PHILADELPHIA ELECTRIC COMPANY

August 2, 1984

Subject: Limerick Generating Station
Response to Procedures and Systems Review
Branch (PSRB) Questions

Selection of LGS Containment Vent Pressure

LGS Containment Venting Provisions

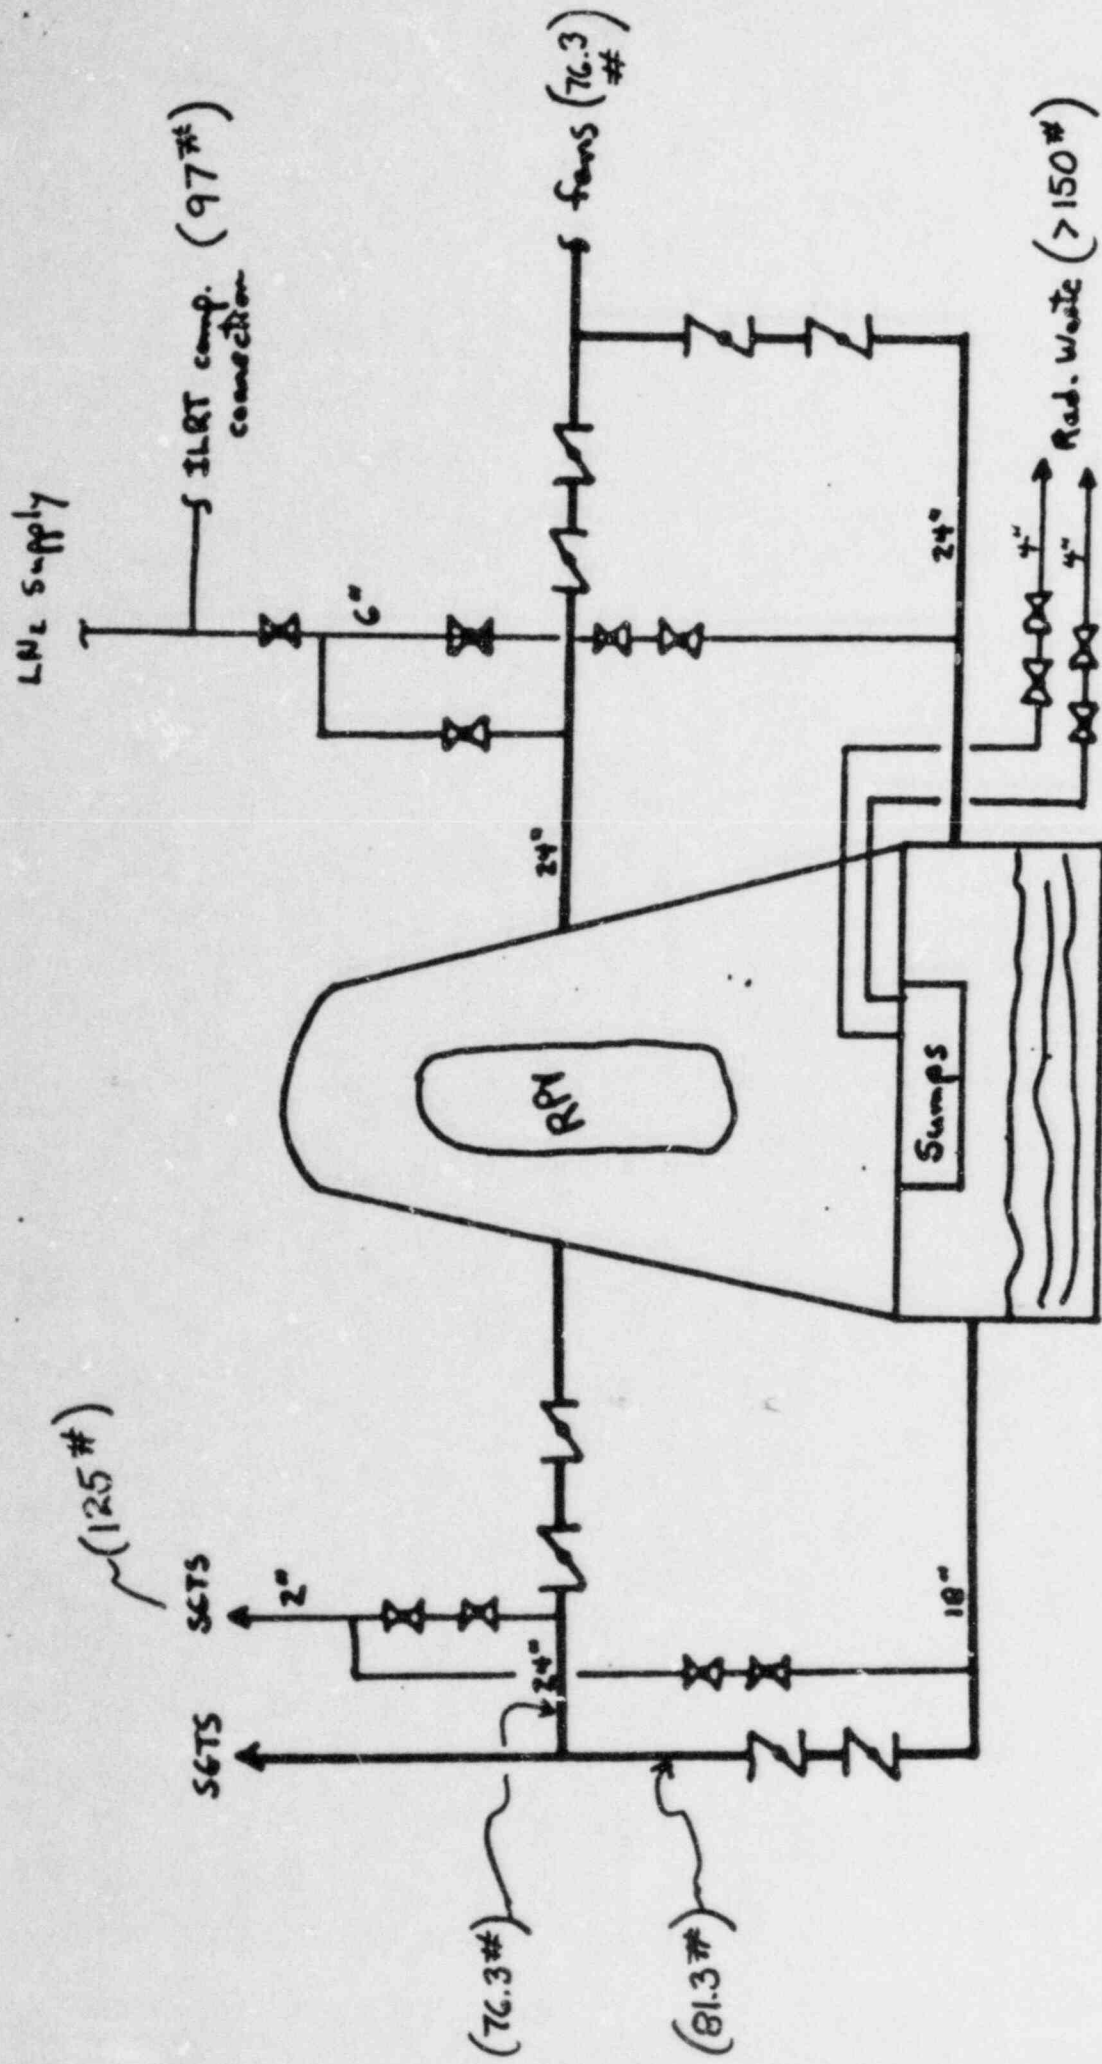
- The isolation valves in the above vent paths have been determined to be operable (i.e. - for opening and closure) for differential pressures ranging from 76 psid to over 150 psid. The evaluation of valve operability has included consideration of all relevant loads, including flow induced dynamic effects. Valve performance characteristics have been derived from analysis and test results. Those valves with the lowest differential pressure capability, the 18" and 24" valves, are all oriented such that containment pressure resists valve opening, or assists valve closure. The operability of these valves is limited by the actuator torque available for opening. Thus, valve reclosure would be assisted by containment pressurization. Initiation of the venting sequence at the selected pressure limit will assure that venting is not begun before conditions warrant and that the vent valves will be used before pressures challenging their operability are reached. The differential pressure rating and size of each vent path is indicated on the attached sketch.
